Presentation by Robert H. Gilkeson, Registered Geologist, to the September 24, 2008 Meeting of the Northern New Mexico Citizens' Advisory Board (CAB)

Comment on the lead contamination in the groundwater below the LANL legacy waste disposal site MDA AB and the deficiencies in the LANL groundwater protection practices for monitoring the groundwater contamination from MDA AB

- By Robert H. Gilkeson, Registered Geologist - Report date October 1, 2008

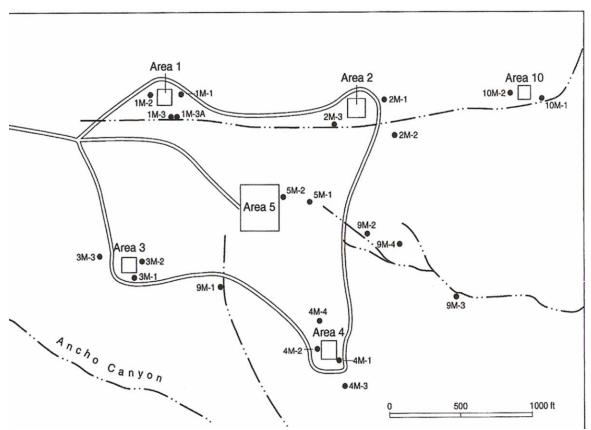
The debris from the high explosive tests were not cleaned up and are the wastes buried in unlined shafts at MDA AB. The improper waste disposal practices have caused a large plume of lead contamination in the regional aquifer below Frijoles Mesa. The nature and extent of groundwater contamination below MDA AB is not known because there are <u>no</u> reliable groundwater monitoring wells. The groundwater may be contaminated with the other hazardous and radioactive wastes that are buried in MDA AB. Figure 1 is a map that shows the locations of the four test areas in MDA AB (Areas 1, 2, 3 and 4) where the shafts were located for the hydronuclear tests. A large number of the underground tests were performed in Area 2 and the amount of land where the tests were performed at Area 2 is much larger than displayed on Figure 1.

Figure 2. Map Showing The Locations Of The Old Test Wells DT-5A, DT-9 And DT-10 At LANL MDA AB.

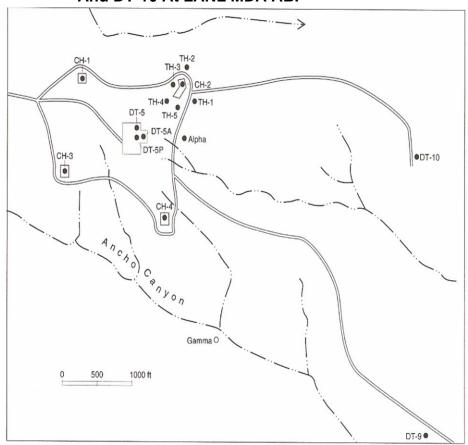
- 10.2 <u>The three old test wells are located too distant from MDA AB for monitoring releases</u>. The locations of the three test wells and the location of MDA AB atop Frijoles Mesa are shown on Figure 2. The direction of groundwater flow below MDA AB is to the east. The distance of the wells from the disposal areas is summarized below:

- Well DT-5A is approximately 1,100 ft southeast of Area 1.
- Well DT-5A is approximately 800 ft south-southwest of Area 2.
- Well DT-5A is approximately 1,000 ft north-northwest of Area 4.

- Well DT-10 is approximately 4,800 ft east of Area 1, 3,400 feet east of Area 2 and 3.600 feet northeast of Area 4.
- Well DT-9 is approximately 6,000 ft southeast of Area 2, 7,000 feet southeast of Area 1 and 4,500 ft southeast of Area 4.

- Monitoring wells should be located at distances not greater than a few hundred feet from the test areas. The fact that NMED is aware of the need for monitoring wells to be located close to MDA AB is described below in Section 11.0.

- Maximum dissolved lead measured in well DT-9 was 95 ug/L.
- Well DT-9 is approximately 6,000 ft southeast of Area 2, 7,000 feet southeast of Area 1 and 4,500 ft southeast of Area 4.

Figure 4. The High Permeability Zones In The Regional Aquifer Below The Los Alamos National Laboratory

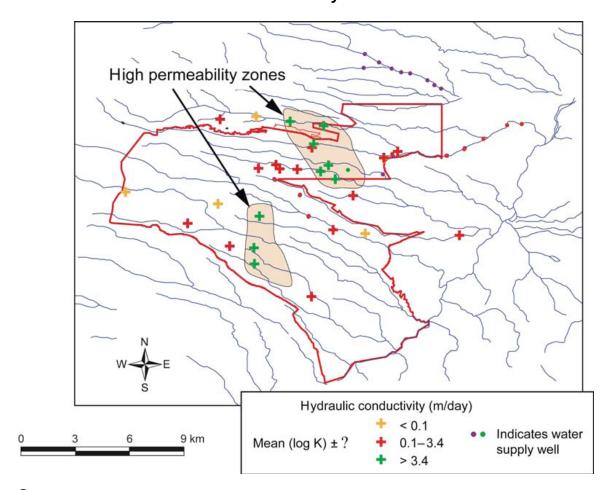
13.0 <u>LANL's careless groundwater protection practices leave the large groundwater resource in the southern region of the Laboratory at risk of groundwater contamination by the wastes buried at MDA AB</u>. Figure 4 is a map from a LANL report that identifies a zone in the southern part of LANL where the regional aquifer is highly productive. Figure 4 identifies the productive zone to be located immediately east of MDA AB based on the low Ksat measured by the pumping test performed in old test well DT-5A.

However, the reason a low Ksat was measured for well DT-5A was probably because the ability of the well to produce water was greatly reduced by the plugging action of the bentonite clay from the mud-rotary drilling method. For comparison, the screened intervals in wells DT-9 and DT-10 were installed with the cable-tool drilling method that did not use any bentonite clay drilling muds. In addition, the regional data show that the Totavi Lentil Formation is a formation of layers of coarse river gravels that are highly productive of groundwater in the southern part of LANL. The greatest thickness of the Totavi Lentil strata is at well DT-5A. The thickness of the Totavi Lentil at each of the three old test wells is as follows: DT-5A - 52 ft; DT-10 - 46 ft; and DT-9 - 38 ft.

In fact, the available information shows that the southern "High Permeability Zone" is at least double the size displayed on Figure 4 and is present below MDA AB and to the southeast the zone includes well R-31 which is shown on Figure 4 as the red symbol located approximately one mile to the southeast of the high permeability zone.
